Light Fixture Selection

Jack Siegel Memorial Plaza

Proposed Fixture – August 2021

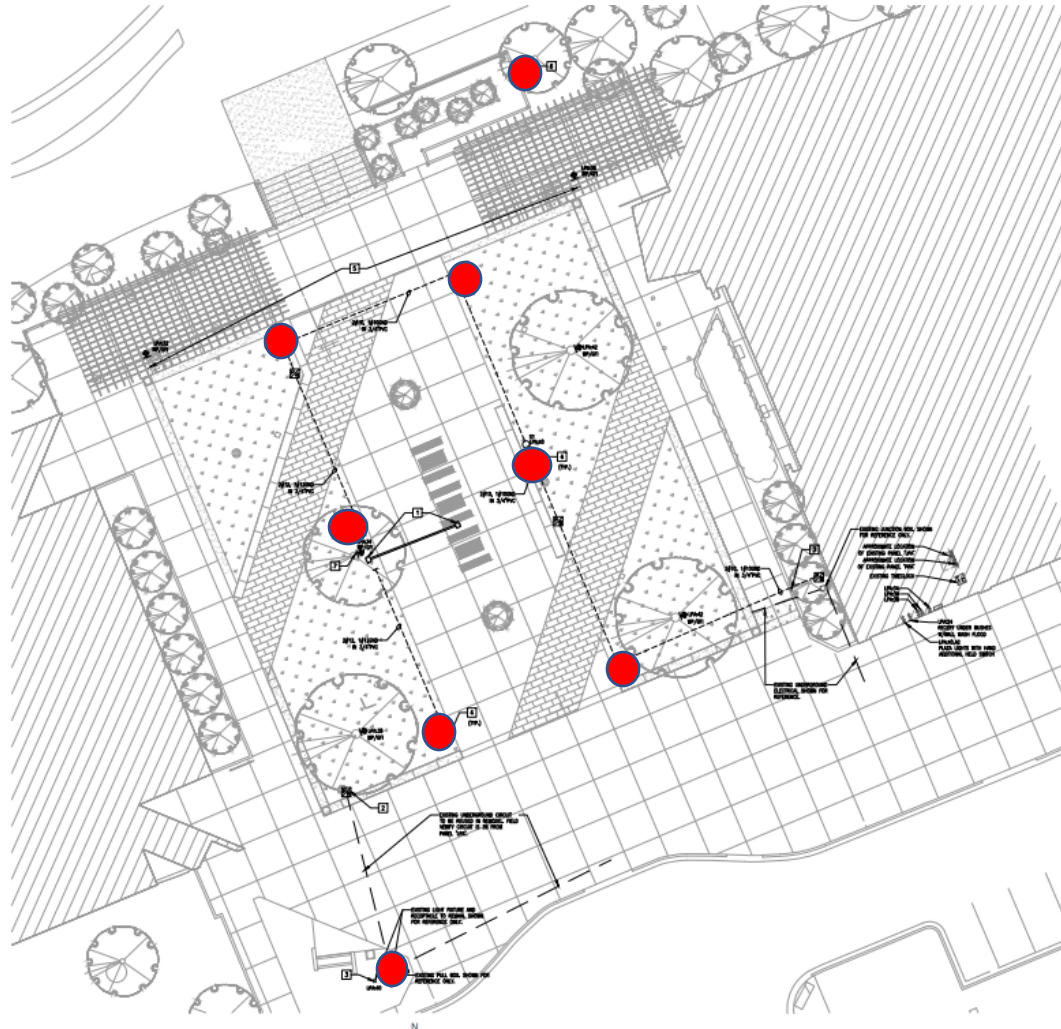
- "Knight Pedestrian" Light Fixtures by Forms+Surfaces
- Would match the existing fixture at memorial bench
- Further design and researched after Committee approvals determined that these fixtures do not throw much light into the area
- 17 fixtures would be needed to properly light the plaza with foot candles, with the target range of 1 F.C. to 5 F.C.
- Permit review determined that even with the 17 new fixtures, lighting levels were still not adequate on the stairs down to the pond (less than 1 F.C. in that area).
- The proposed change order from F. H. Paschen for these fixtures was \$121,000.

- "Ouro " Light Fixtures by KIMLIGHTING by Hubbell
- 8 fixtures would be needed to properly light the plaza with foot candles, with the target range of 1F.C. to 5 F.C.
- With these fixtures, permit review team indicated that the lighting levels were adequate on the stairs down to the pond (more that 1 F.C. in that area).
- The existing "Knight" fixture at memorial bench would also be replaced as part of this change order to provide a cohesive look to the plaza.
- The proposed change order from F. H. Paschen for these fixtures was \$53,435.
